PROJECT: **City of Sterling Heights – Dodge Park Improvements**
Sterling Heights, MI

DMA PROJECT NO: **16078A**

ADDENDUM NO: **3**

ISSUE DATE: **July 7, 2017**

job no. 16078A sheet no. TB-A1

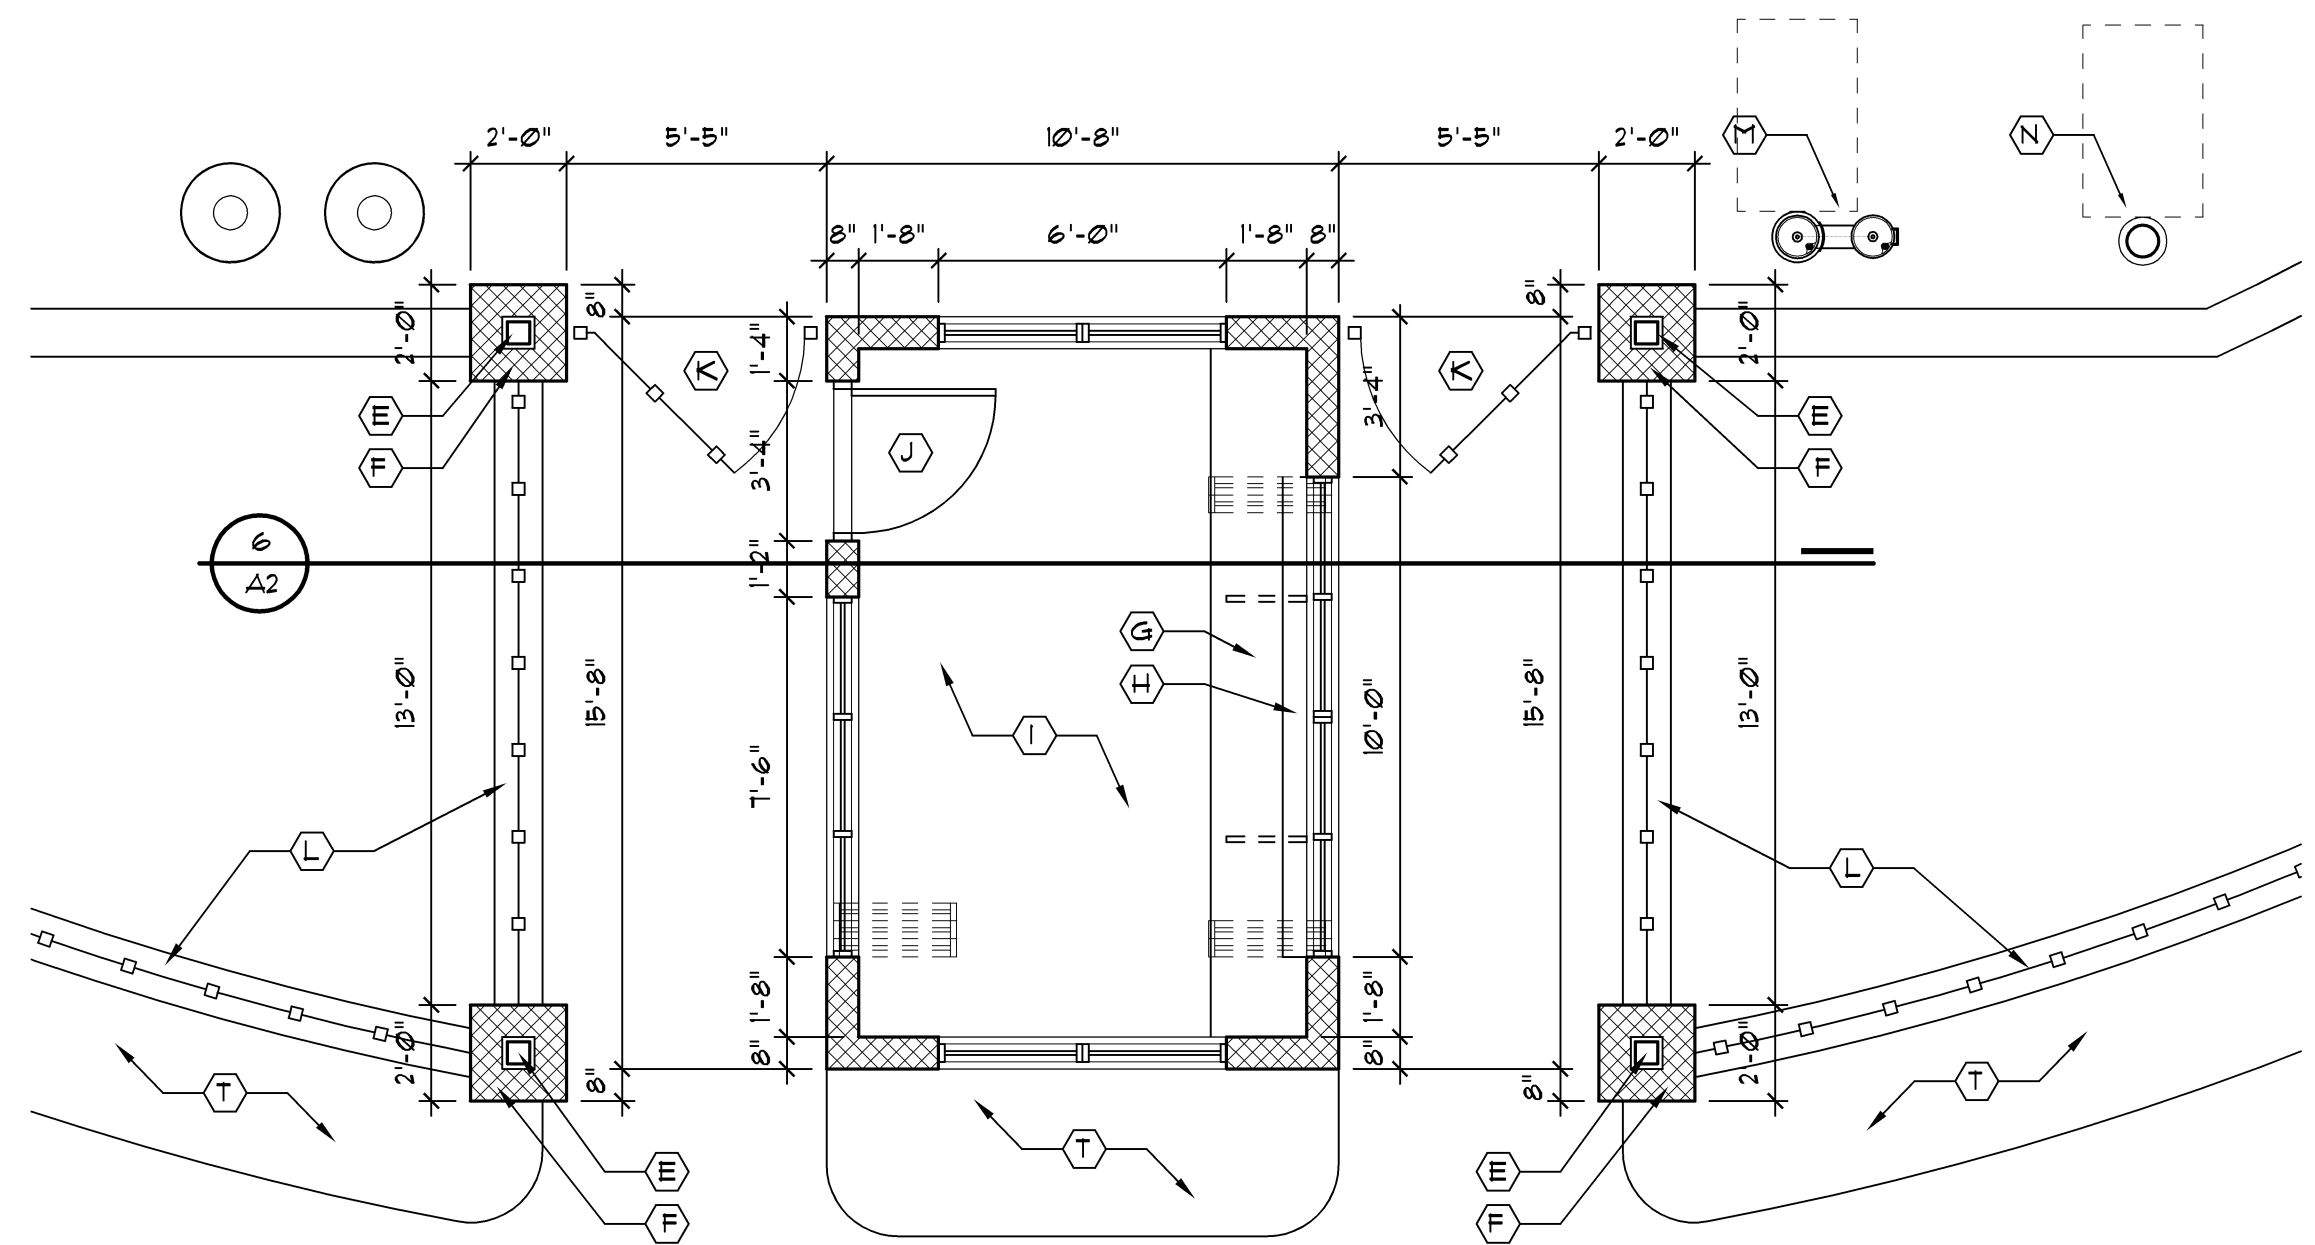
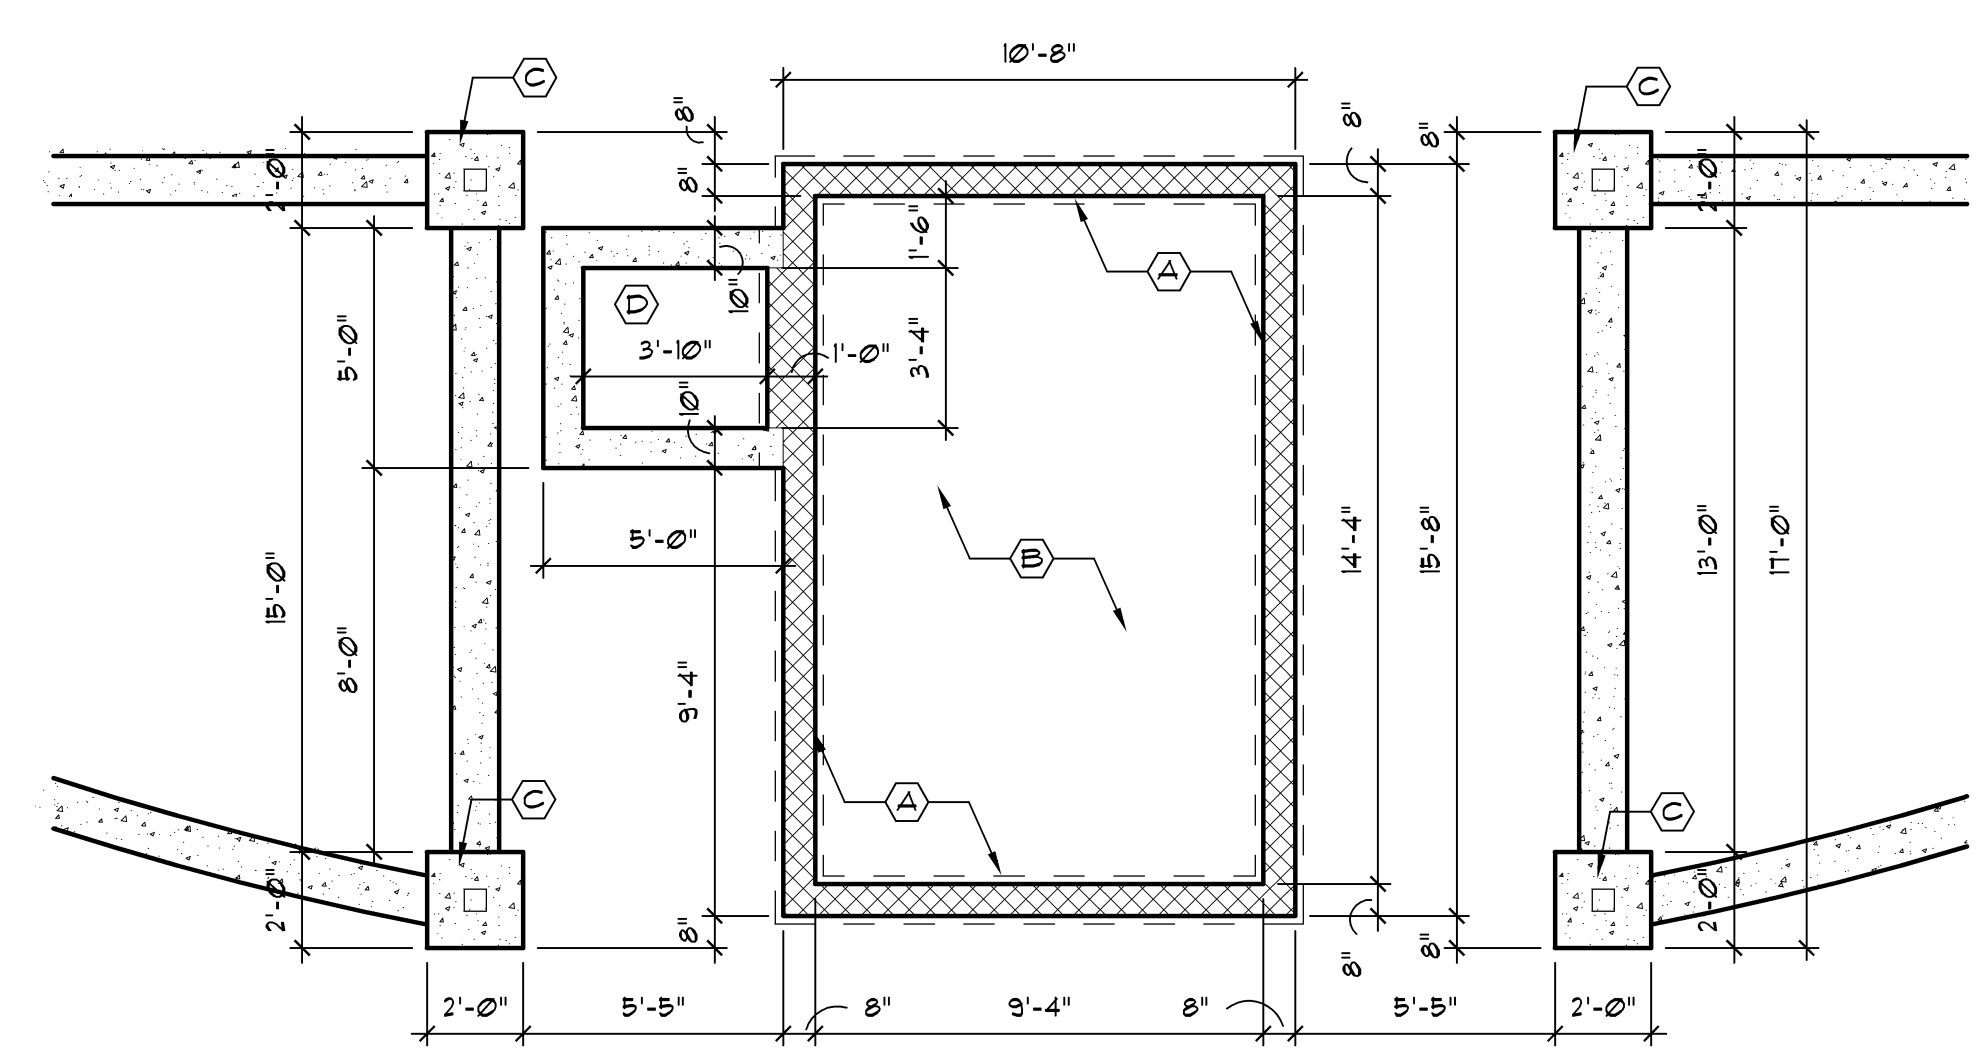
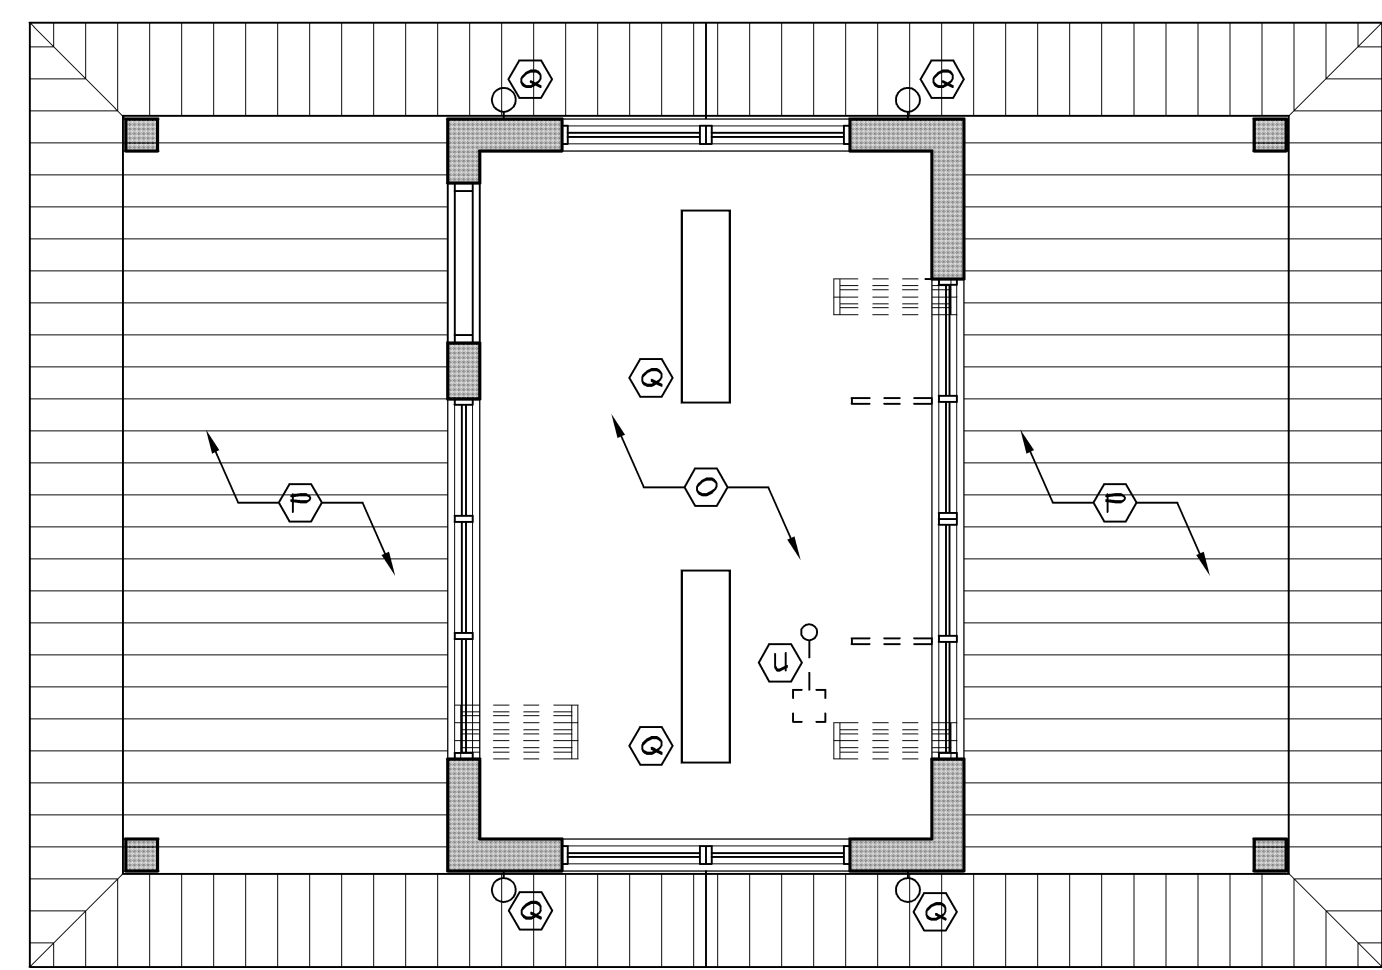
1. Revised sheet T002 Sheet Index to indicate added irrigation sheets IRR-1 through IRR-5.
2. Revised sheet T002 Sheet Index to indicate drawings revised as part of Addendum #3.
3. Revised sheet TB-A1, Ticket Booth Plans, to indicate the hardware set number for the entry door.
4. Revised sheet RRB-A2, Renovated Restroom Building Schedules, to add the hardware set numbers to the Door Schedule.
5. Revised sheet FM-A1.2, Farmers Market Floor Plan, to clarify Seasonal Ice Rink design criteria and responsibility.

sheet no:
LS-1 of 5

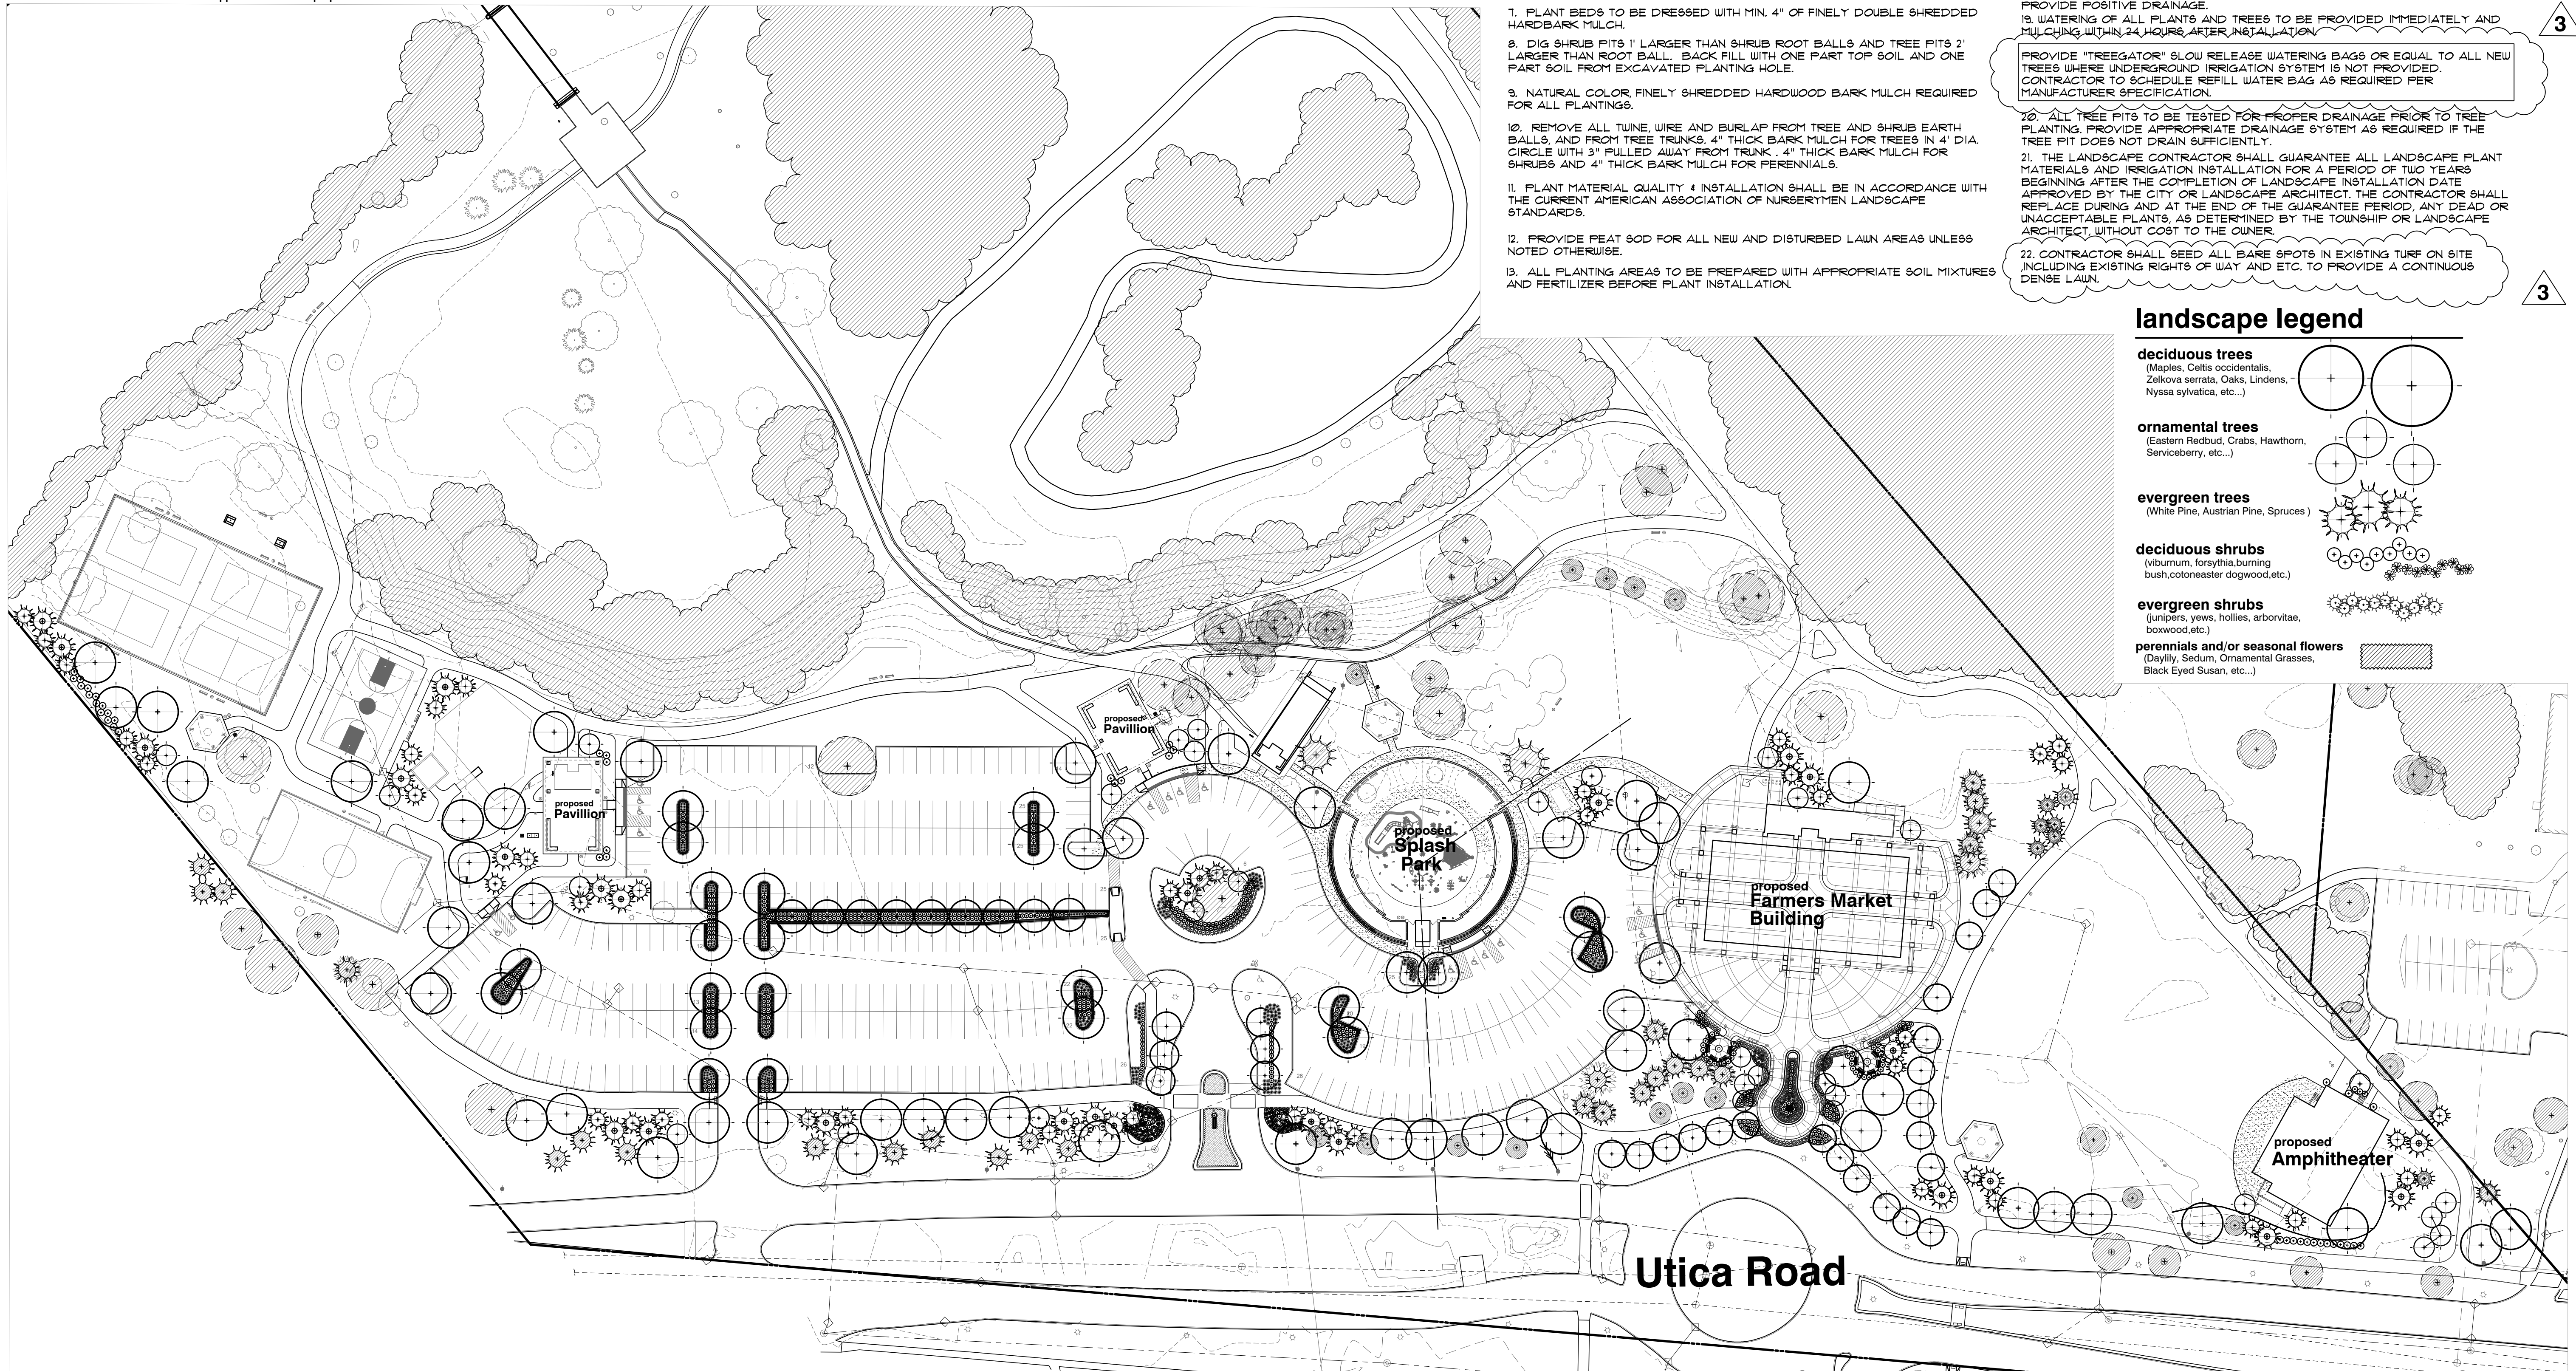
1. Revised sheet LS-1 to add “Treegator” slow release watering bags and seeding of bare spots in turf throughout site.
2. Revised sheet LS-2 to add “Treegator” slow release watering bags and seeding of bare spots in turf throughout site.

- CONTRACTOR SHALL SEED ALL BARE SPOTS IN EXISTING TURF ON SITE INCLUDING EXISTING RIGHTS OF WAY AND ETC. TO PROVIDE A CONTINUOUS DENSE LAWN.

PROVIDE "TREEGATOR" SLOW RELEASE WATERING BAGS OR EQUAL TO ALL NEW TREES WHERE UNDERGROUND IRRIGATION SYSTEM IS NOT PROVIDED. CONTRACTOR TO SCHEDULE REFILL WATER BAG AS REQUIRED PER MANUFACTURER SPECIFICATION.
